# SAN FRANCISCO PLANNING DEPARTMENT

**MEMO**

**RE:** Review and Comment for 1 Stockton Street  
Case No. 2015-014090PTA

prepared for: **T-Mobile**  
**San Francisco Store Signature**  
**Exterior Design**  
March 4, 2016

Dimensional Halo-lit sign

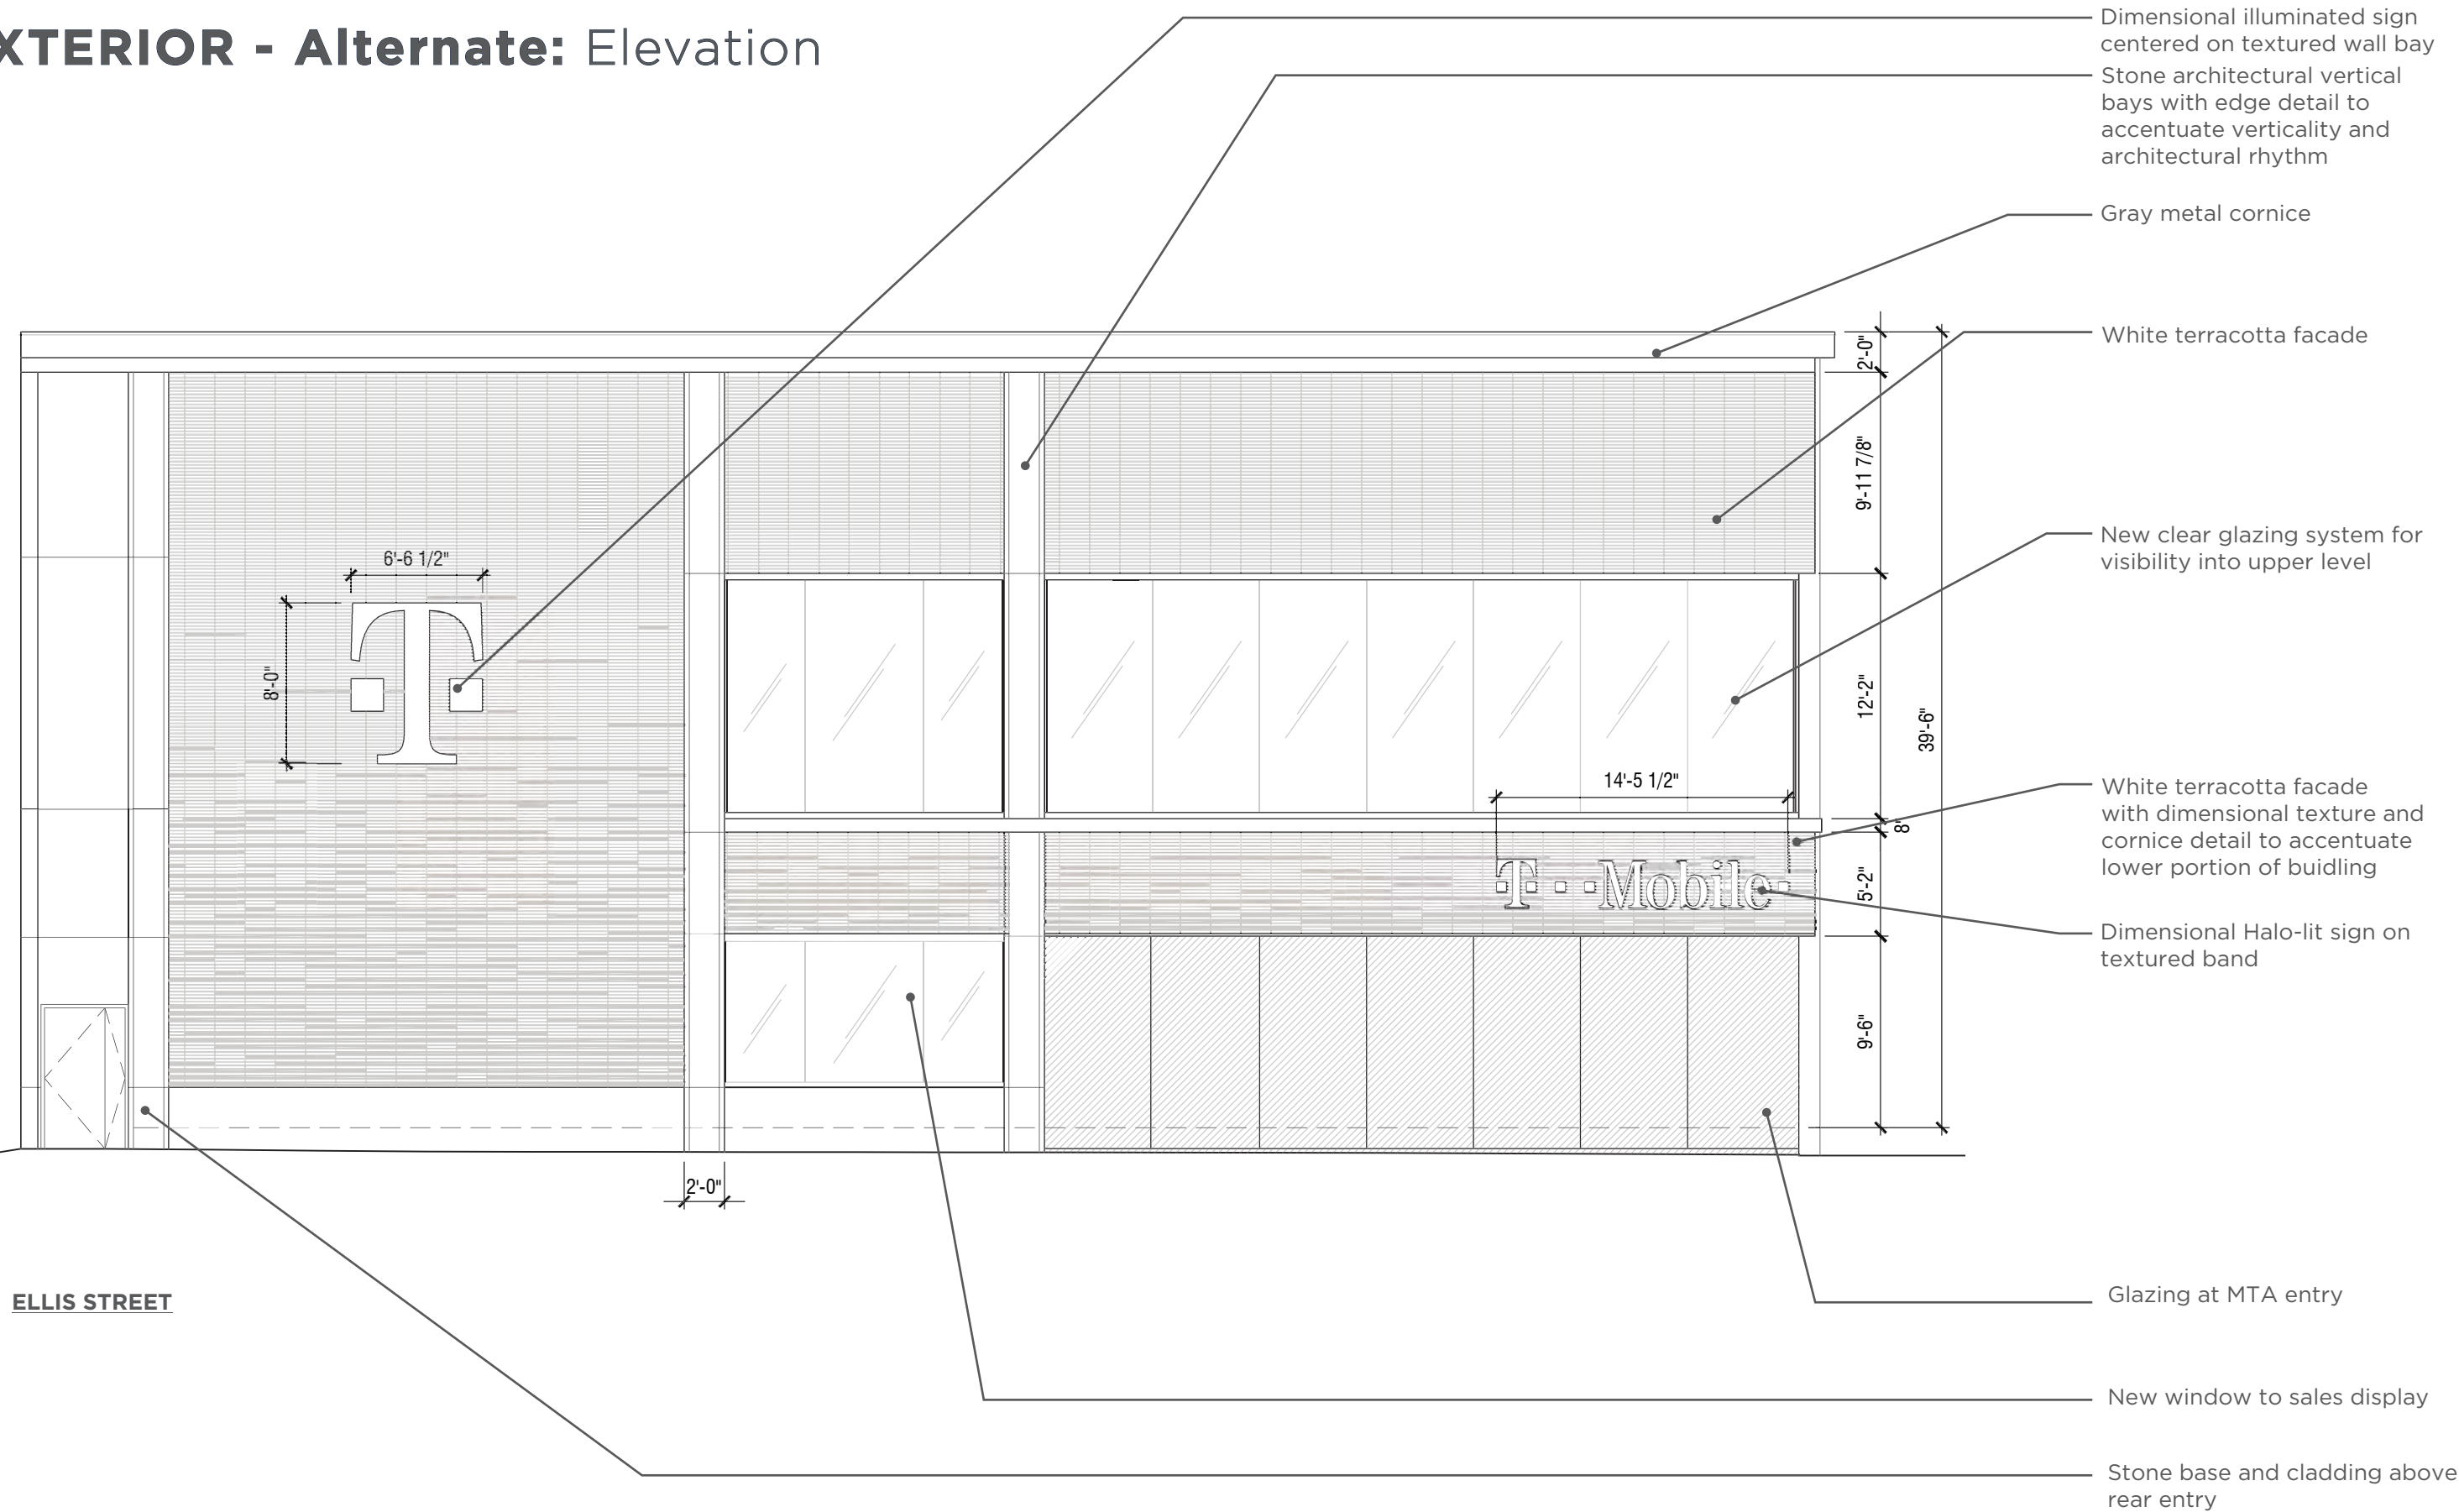
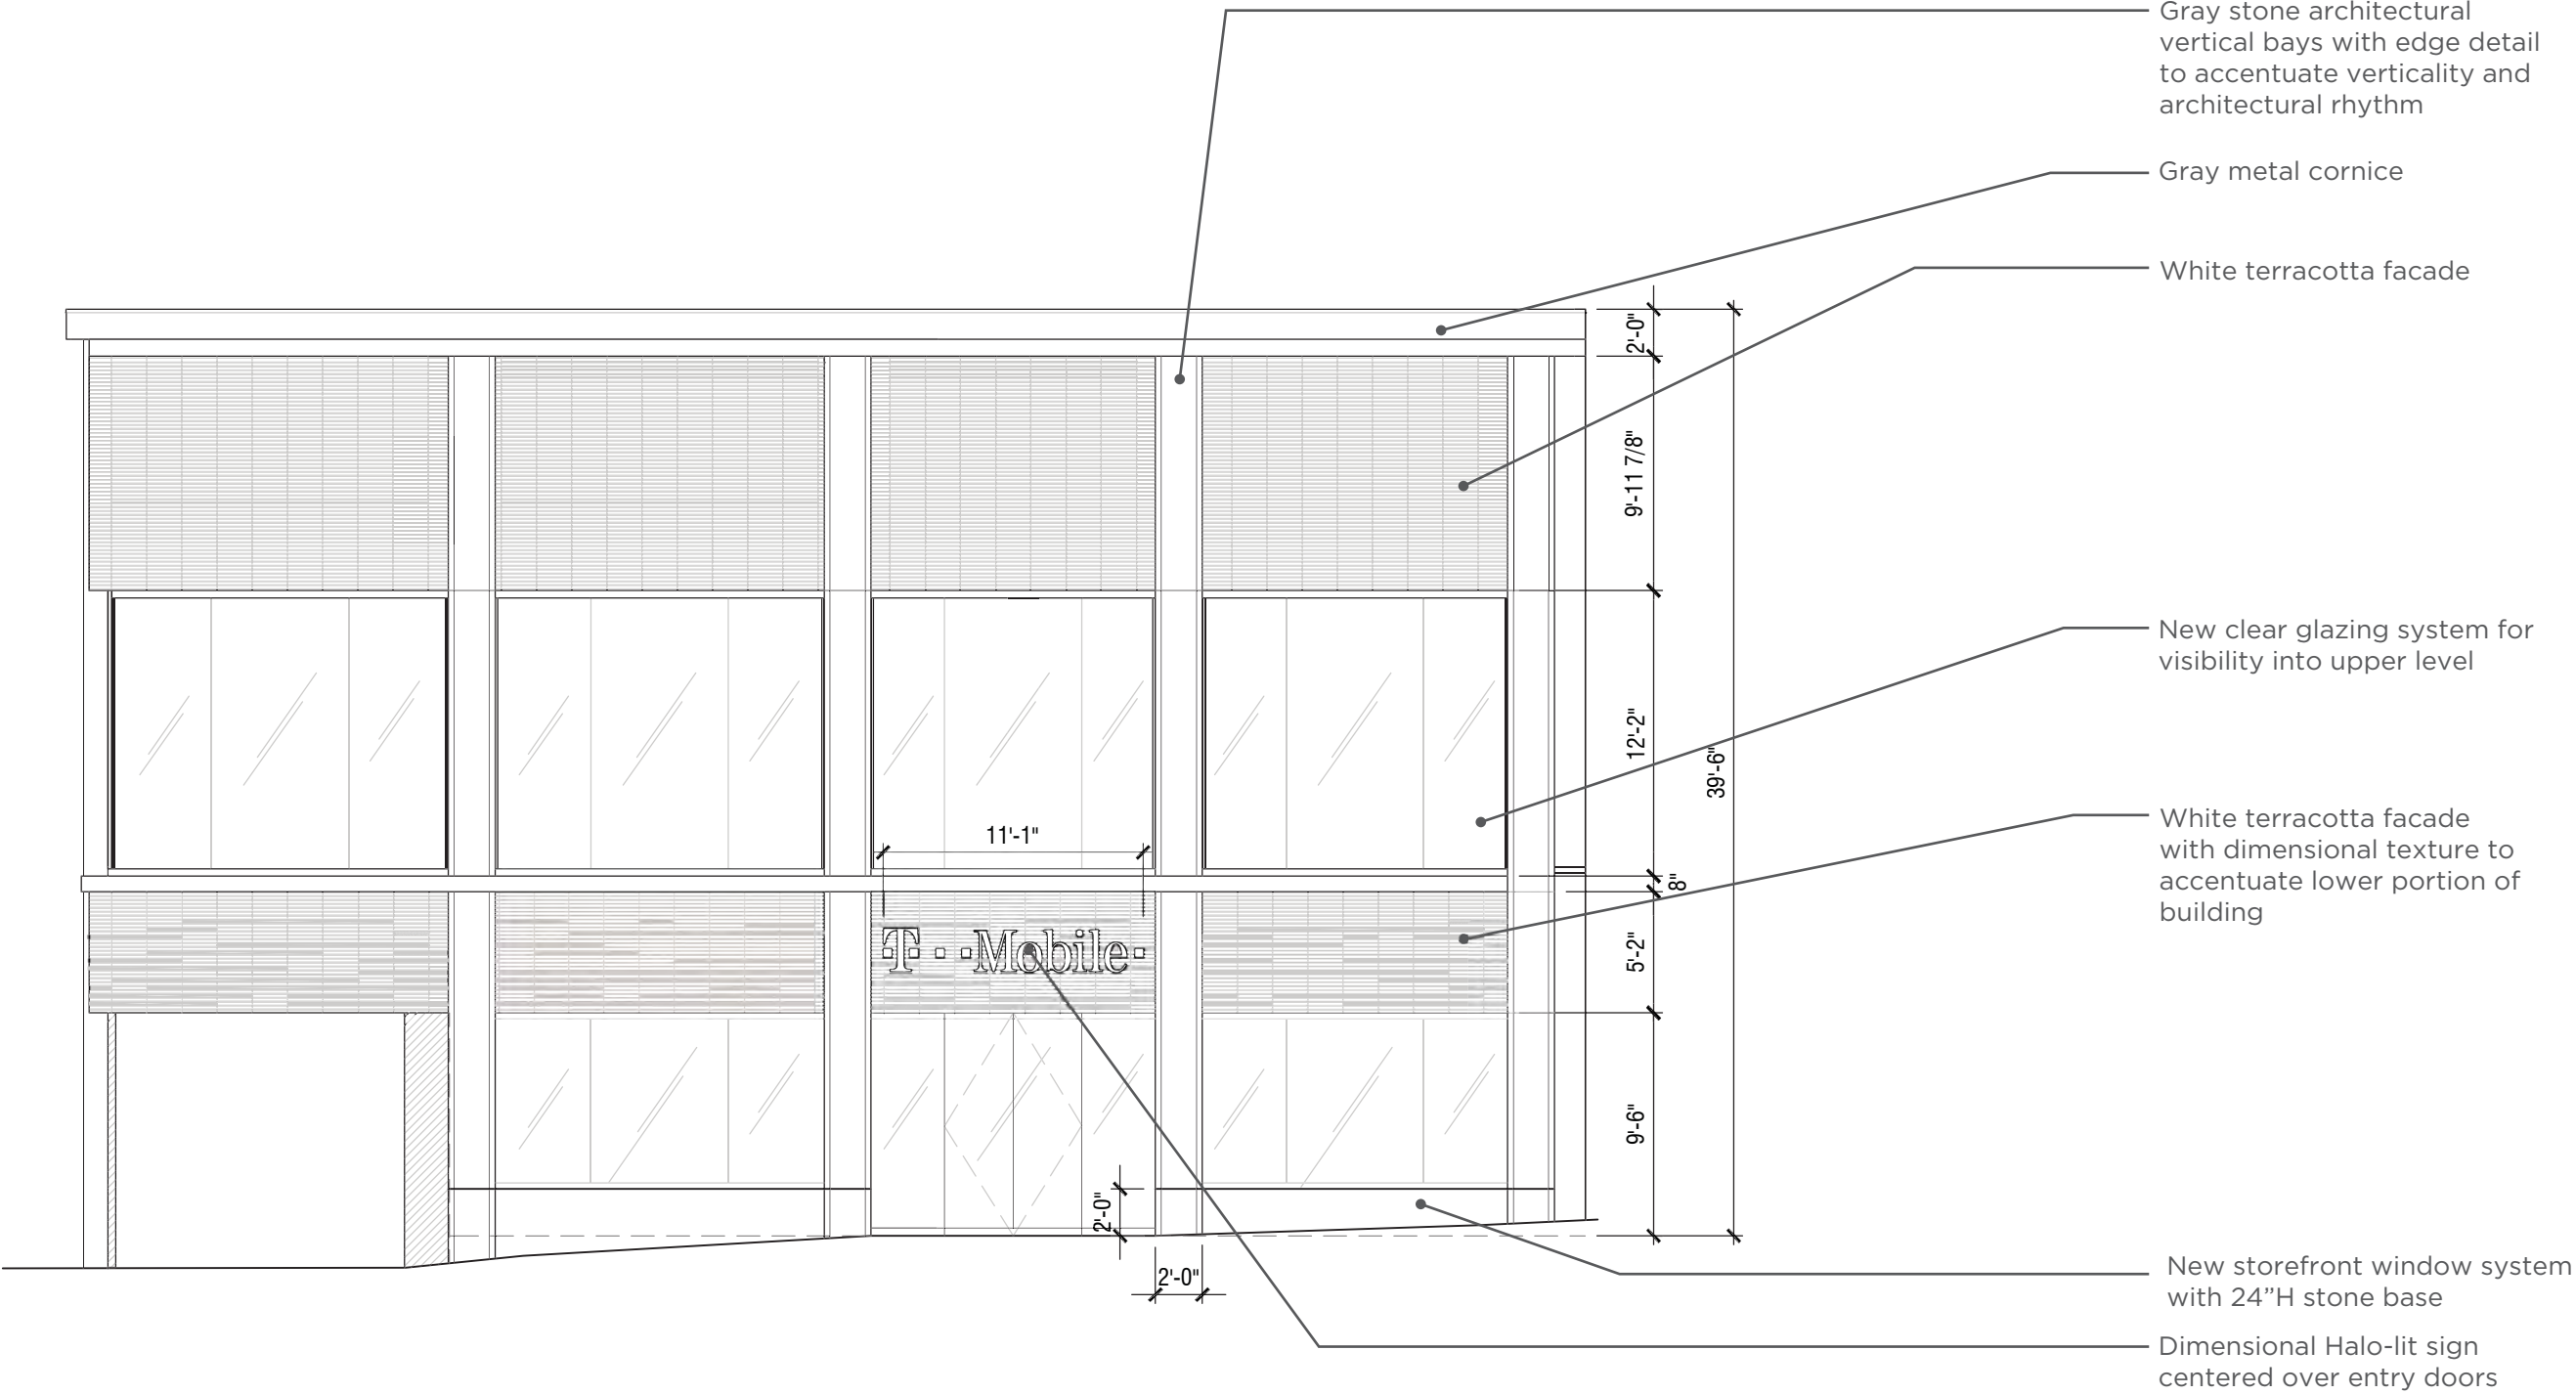
*The project sponsor has provided two versions of the façade for discussion: in Option A, the horizontal spandrel between floor levels is continuous, breaking the vertical piers into two parts; in Option B, the vertical piers extend the height of the building, breaking the horizontal spandrel into segments.*

*Both options address issues of compatibility with the District. Option A, with the continuous spandrel, emphasizes the two-part vertical composition and more clearly delineates the building base, but it also diminishes the vertical expression of the façade bays, which is also an important characteristic of the District, particularly on a building of this size. Option B, with the continuous vertical piers, creates a fenestration pattern consistent with the District and reinforces the vertical expression of the façade, but deemphasizes the horizontal spandrel and two-part composition. Although the horizontal break is important, the vertical expression provided by Option B appears to be most compatible with the massing and composition of buildings in the District. Further, the continuous vertical piers anchor the base of the building.*

- *The Department would like the ARC to provide guidance regarding the two options for the façade design. Both options offer approaches to address compatibility with massing and composition of buildings within the District. The Department believes that Option B, which maintains the continuous vertical piers, is more consistent with the District, as it provides vertical expression on an otherwise low-slung building.*
